72+COLLINS HOTEL & CONDOMINIUM

CITY OF MIAMI BEACH DESIGN REVIEW BOARD

FEBRUARY 2, 2021

GROUND LEVEL - PHASE 1

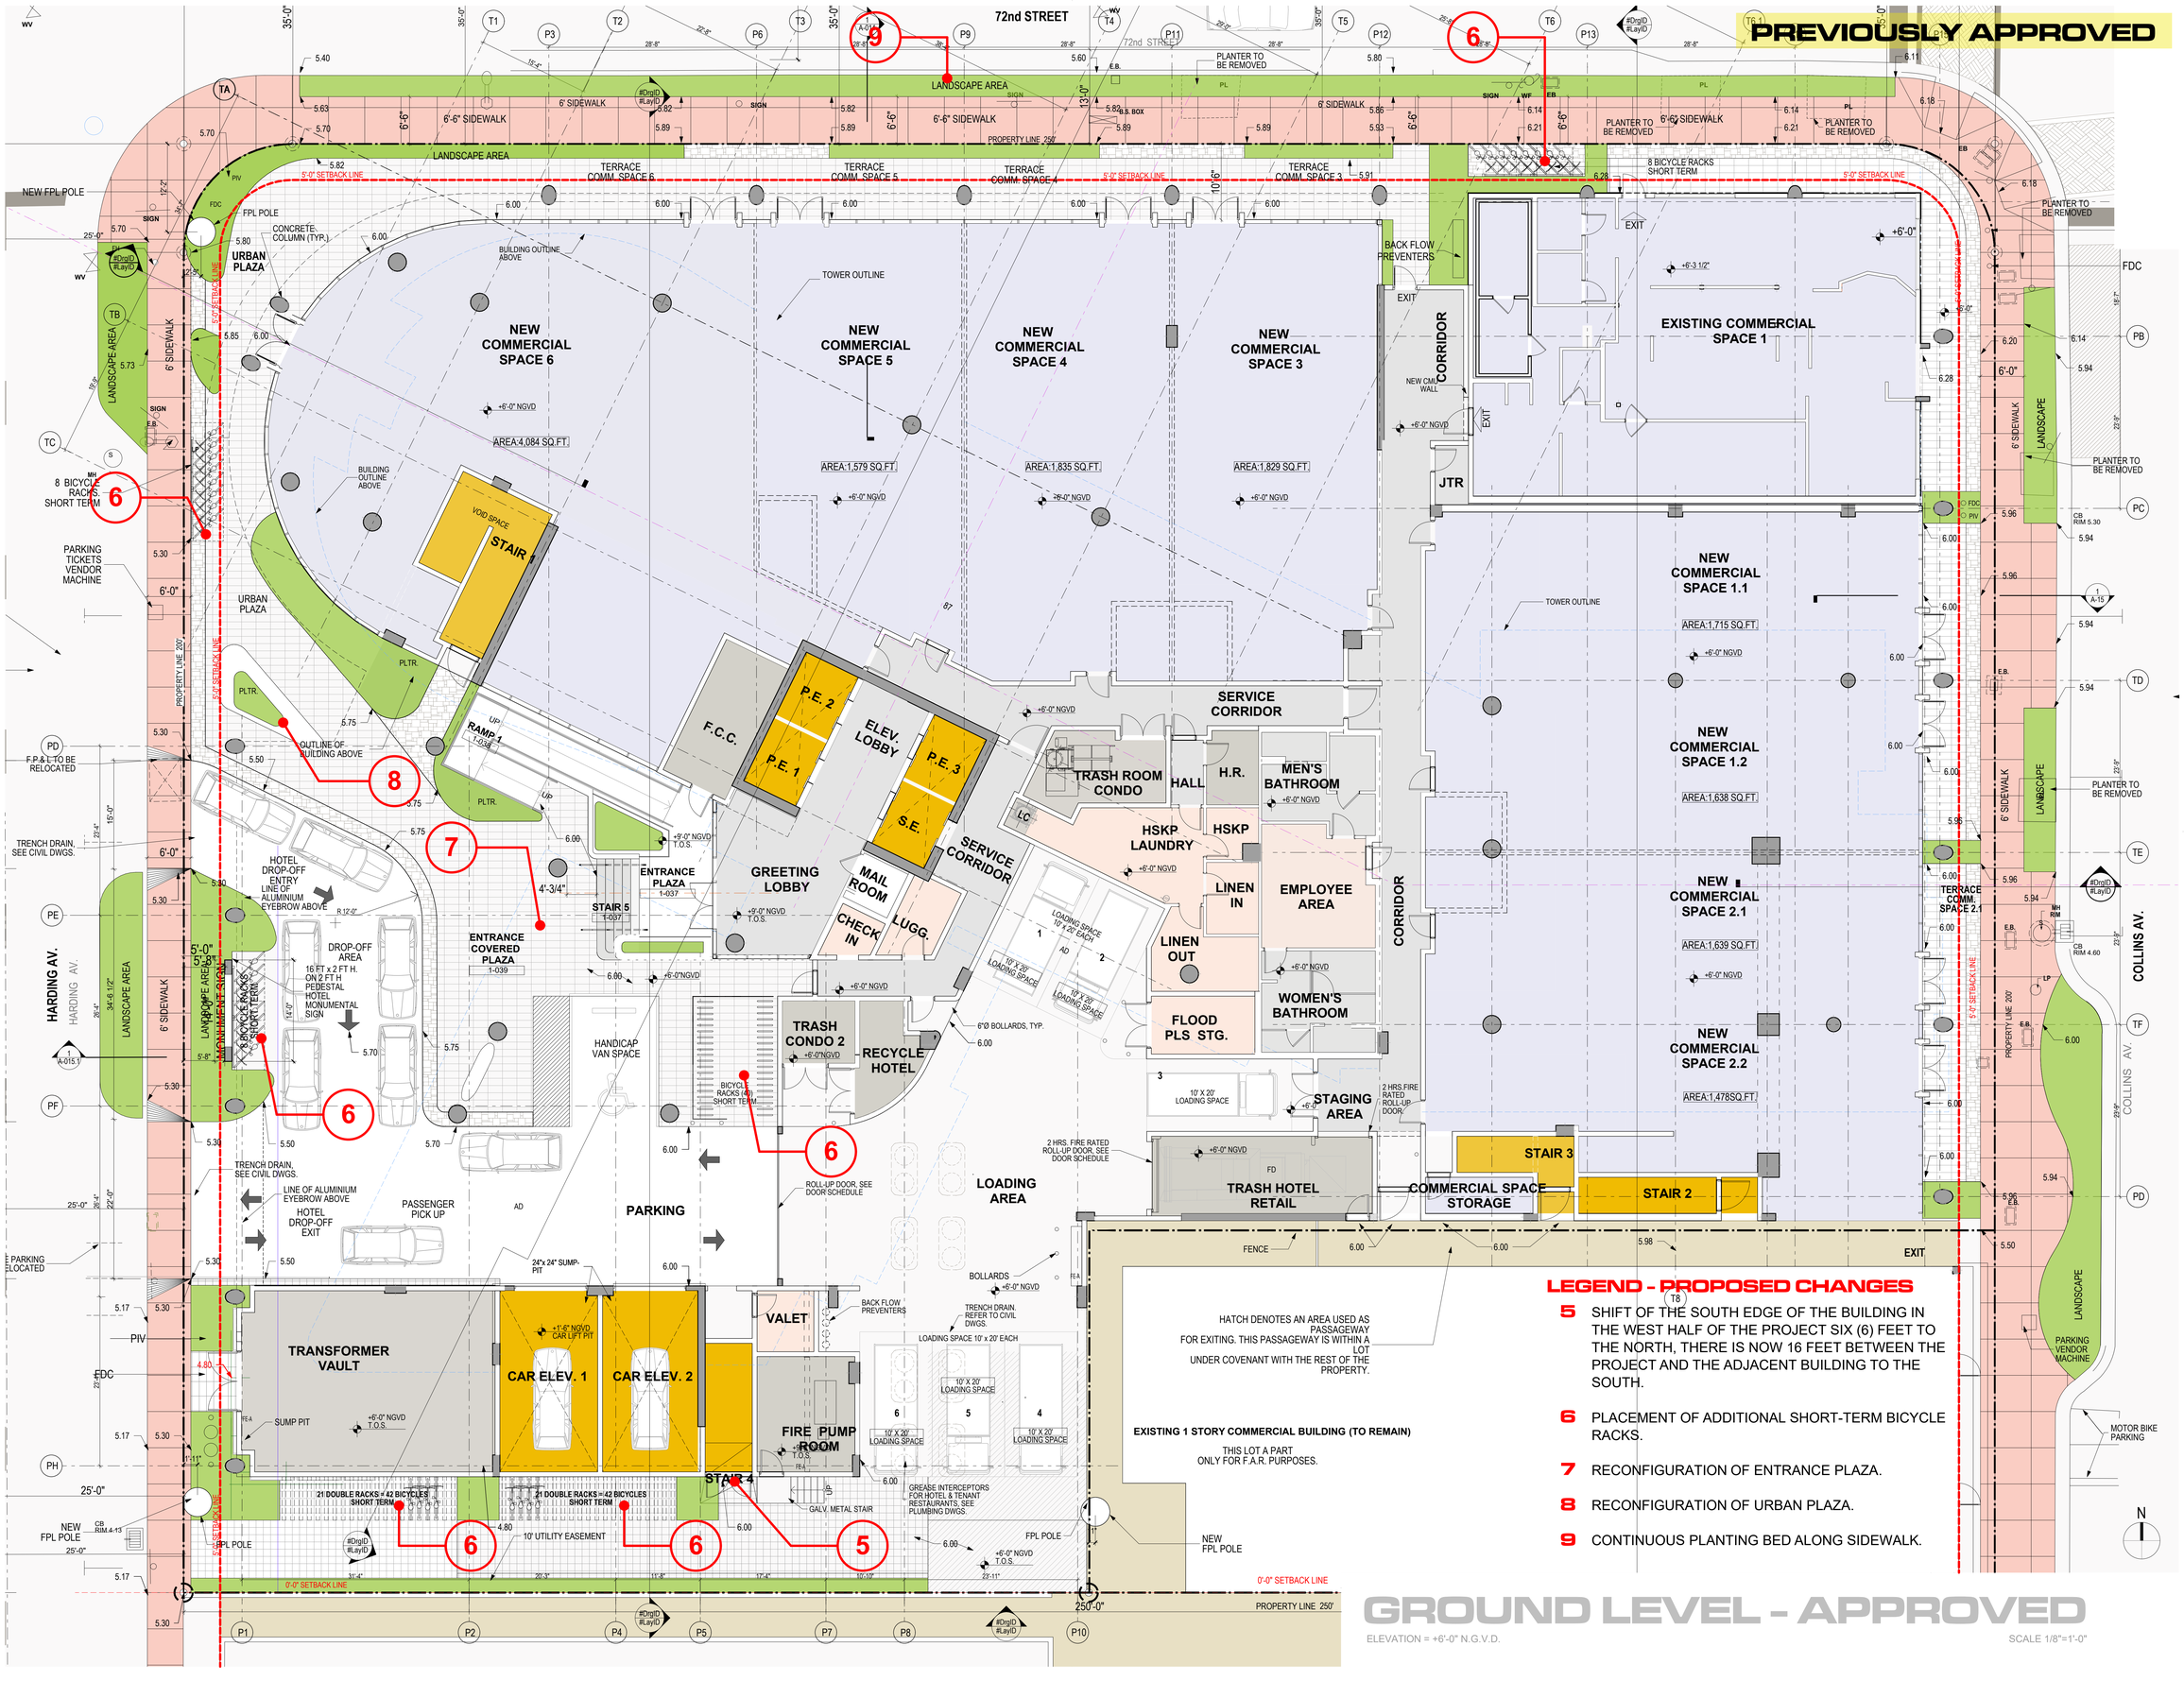
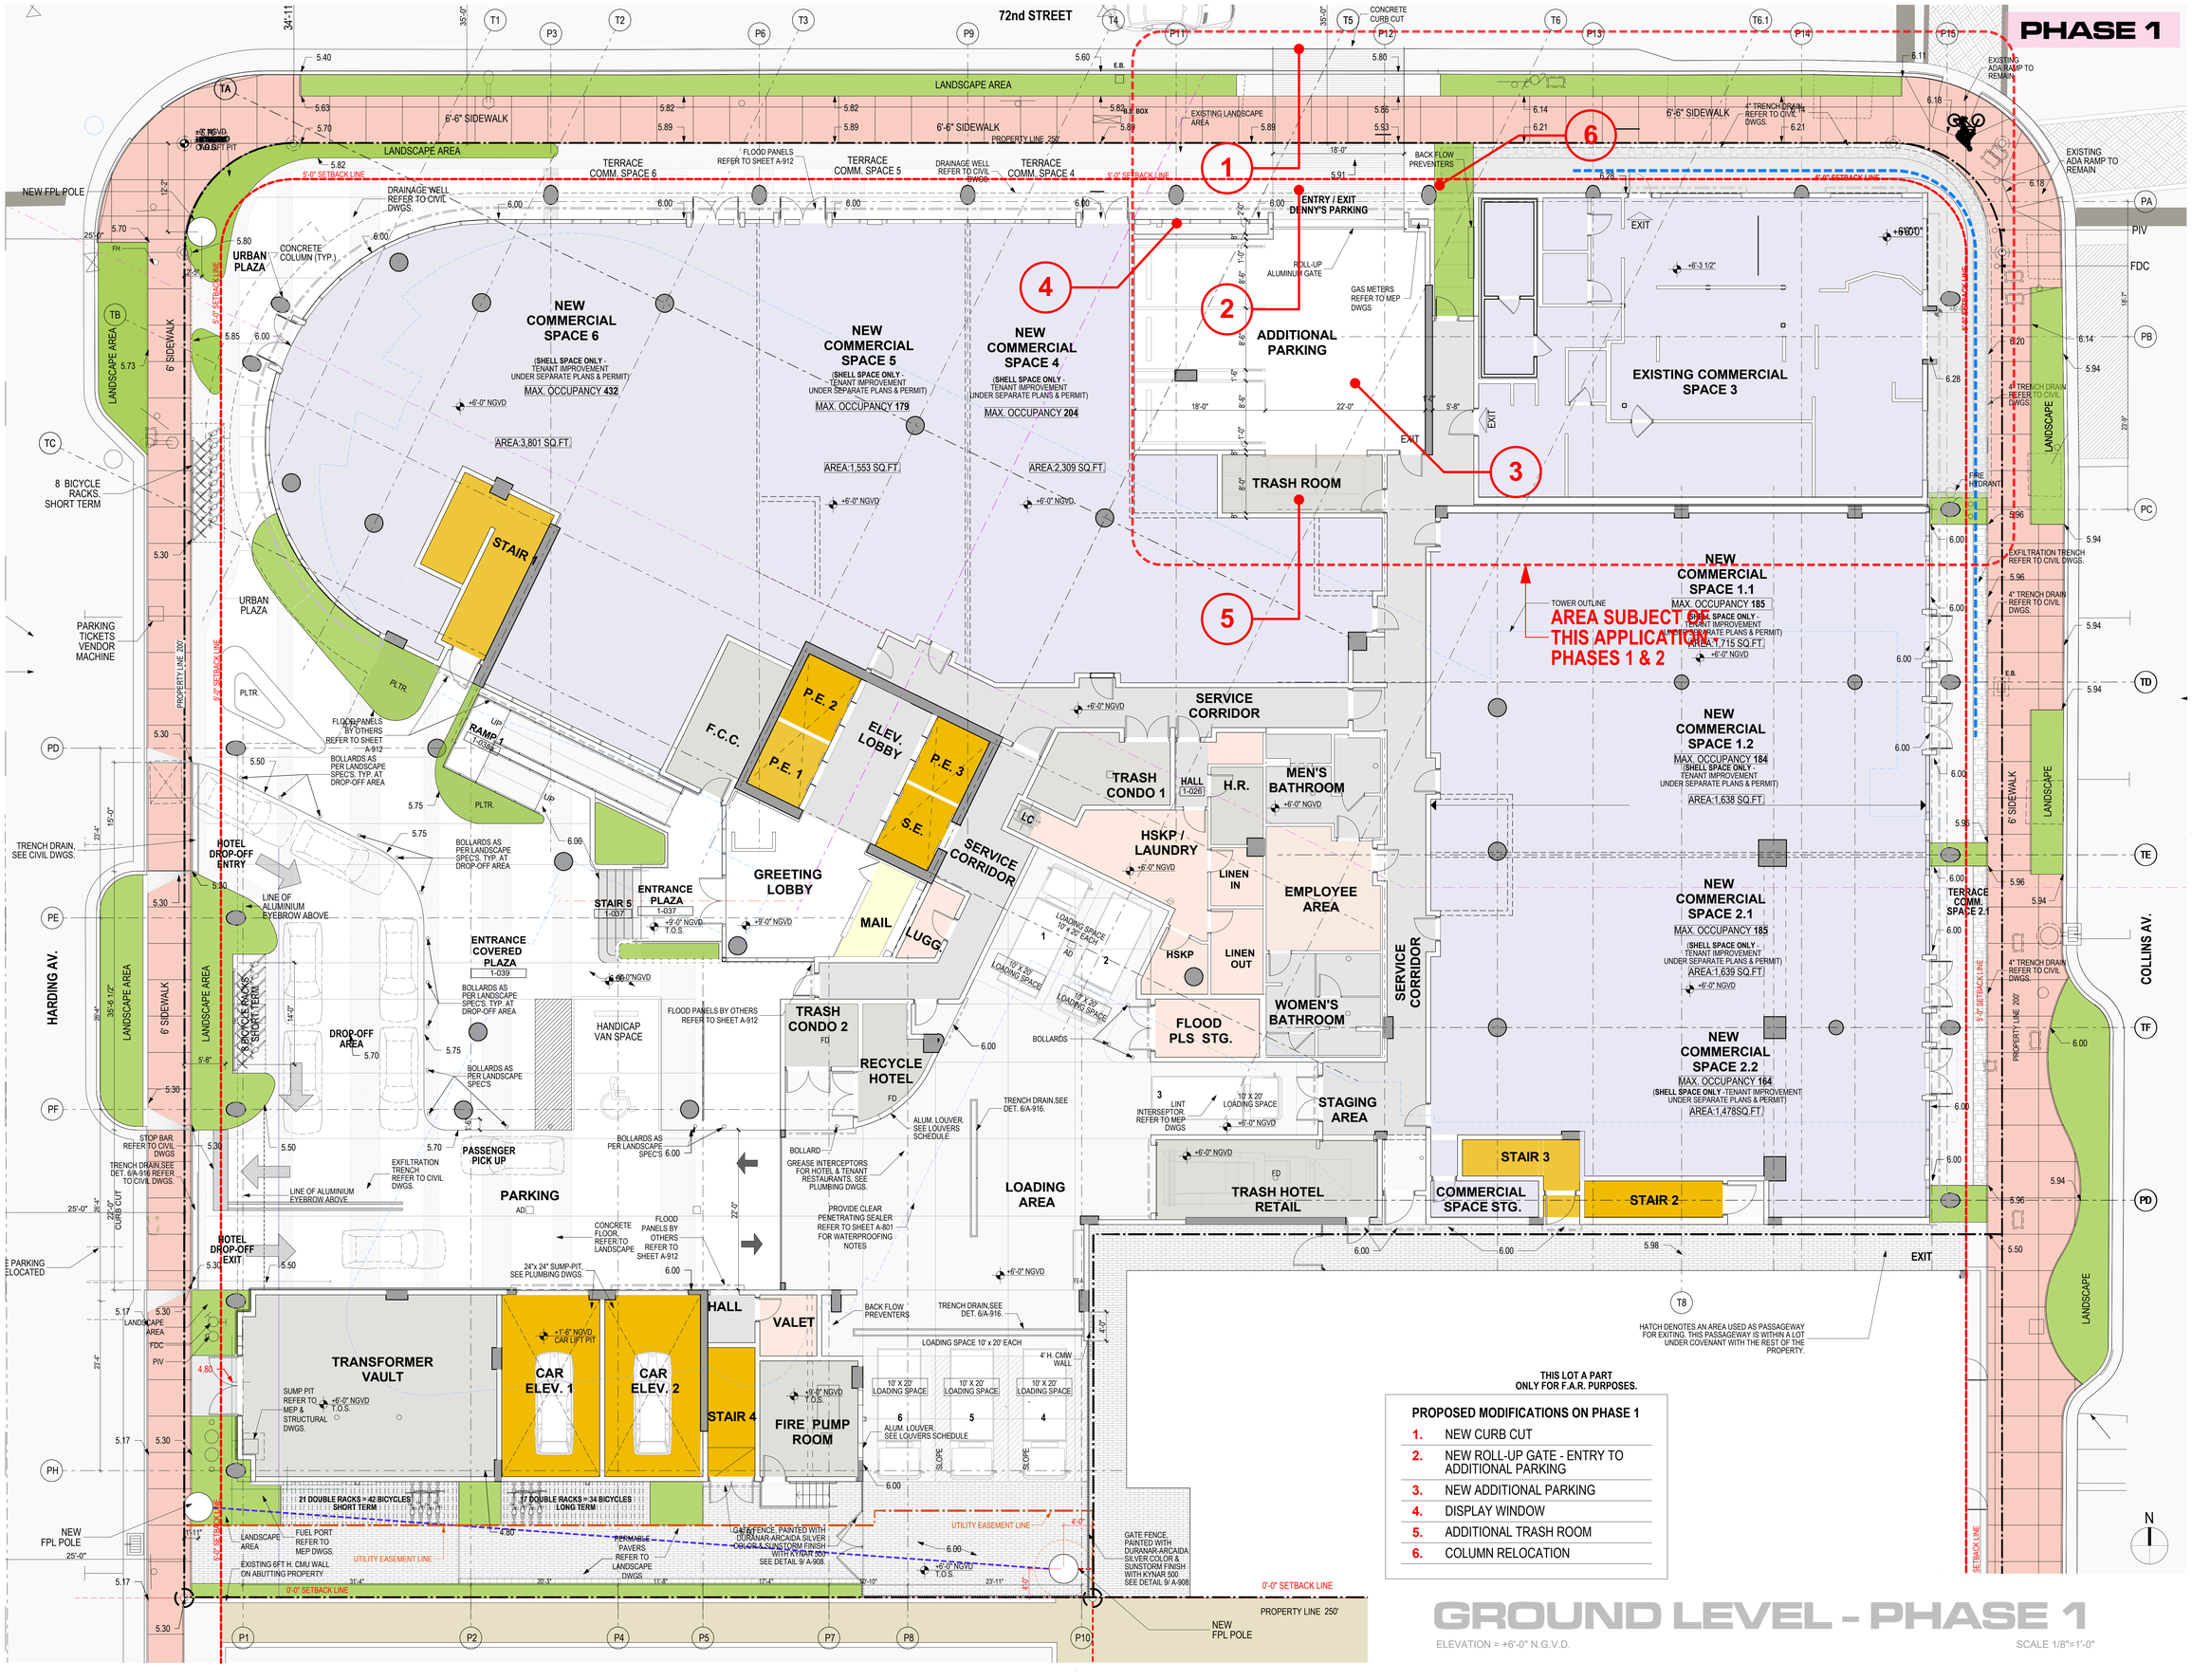
TO TEMPORARILY LEAVE AND INCORPORATE THE SMALL PARKING LOT BEHIND DENNY'S INTO THE APPROAVED PROJECT DURING THE TERM OF THE DENNY'S LEASE AND THEN FILL IN THE PARKING LOT WITH RETAIL SPACE AFTER THE DENNY'S LEASE IS OVER.

LEGEND - PROPOSED CHANGES

5 SHIFT OF THE SOUTH EDGE OF THE BUILDING IN THE WEST HALF OF THE PROJECT SIX (6) FEET TO THE NORTH, THERE IS NOW 16 FEET BETWEEN THE PROJECT AND THE ADJACENT BUILDING TO THE SOUTH.

6 PLACEMENT OF ADDITIONAL SHORT-TERM BICYCLE RACKS.

7 RECONFIGURATION OF ENTRANCE PLAZA.

8 RECONFIGURATION OF URBAN PLAZA.

9 CONTINUOUS PLANTING BED ALONG SIDEWALK.
